TECHNICAL BULLETIN	
	July 1998 TB 1589
Mfg:	CHRYSLER
Model:	TOWN & COUNTRY
Liter:	3.8L
V I N:	L
Year:	91-00

Cylinder Head Modification On
1990-98 Chrysler 3.3 & 3.8L VIN R, T, U & L Engines

Bulletin Diagram: Untitled Graphic #2320 for TB 01589

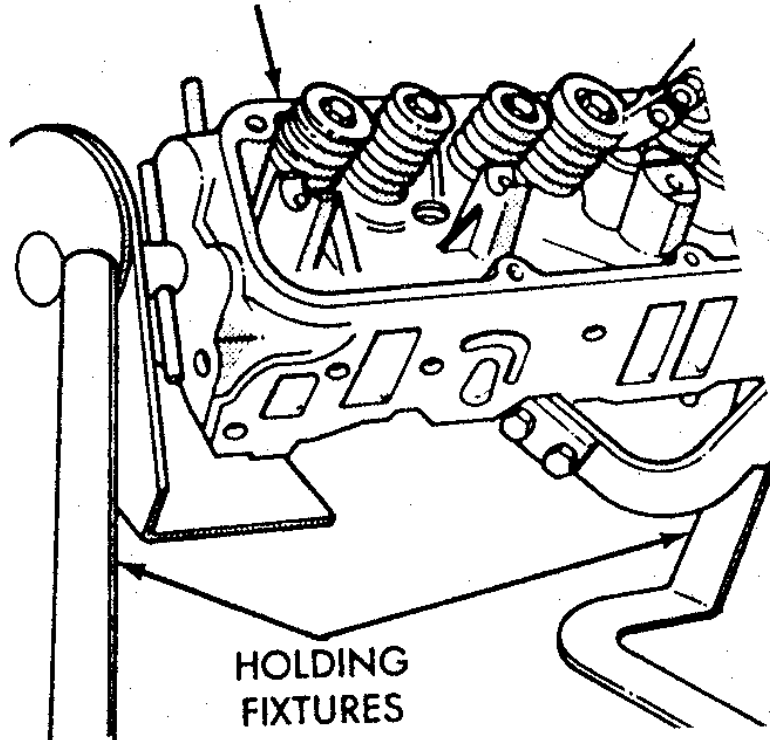
AERA members have reported a cylinder head modification on 1990-1998 Chrysler 3.3 & 3.8L VIN R, T, U & L engines. This modification is being done anytime the cylinder head is removed. One of the reasons for this modification is to prevent possible rocker shaft breakage.

It appears the end rocker shaft bolt may not have sufficient thread depth for all situations of engine operation. Rocker shaft and pedestal breakage have been reported on these engines. During late 1996 production of these cylinder heads, Chrysler modified the end locations of the rocker pedestals. The modification involved drilling and tapping the rocker stand mounting holes an additional .600" deeper. Doing so, reduced the frequency of component breakage. Those locations also require using a longer mounting bolt, Part #6100174.

Many AERA members report doing this modification to these heads anytime they are removed from the engine. Some members have reported the use of a stud and nut on heads that have not been removed from the engine compartment.
